DESIGN CB	DRAWN BY CB	DART AEROSPACE LTD HAWKESBURY, ONTARIO, CANADA	
CHECKED Jah	APPROVED J	DRAWING NO. DSI 9336	REV. A SHEET 1 OF 1
DATE 06.05.19		TITLE BOLT LENGTH CHANGE	SCALE NTS
A	06.05.19	NEW ISSUE

DART SERVICE INSTRUCTION

TO AMEND INSTALLATION INSTRUCTIONS IIN-D412-742 REV.B AND INSTRUCTIONS FOR
CONTINUED AIRWORTHINESS ICA-D412-742 REV.1

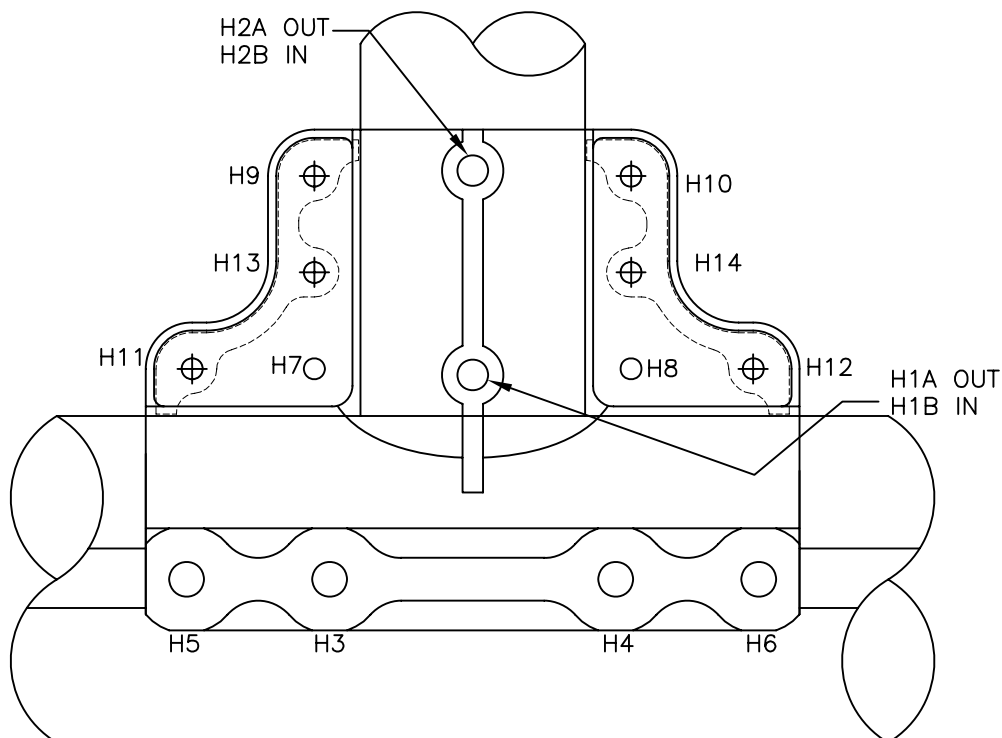
- 1) The AN4C6A bolts installed in holes H7 and H8 in diagram shown below may be replaced with the AN4C7A bolts to ensure a minimum of 1.5 threads in safety.

(Add to 5.1 D412-742-011 (PMA/OEM) FLOAT SKIDTUBE INSTALLATION PARTS LIST)

Item	QTY-011	QTY-041	QTY-015	P/N	Description
55	4			AN4C7A	BOLT

(Add to 5.2 D412-742-013 (APICAL TRI-BAG) FLOAT SKIDTUBE INSTALLATION PARTS LIST)

Item	QTY-013	QTY-043	P/N	Description
55	4		AN4C7A	BOLT
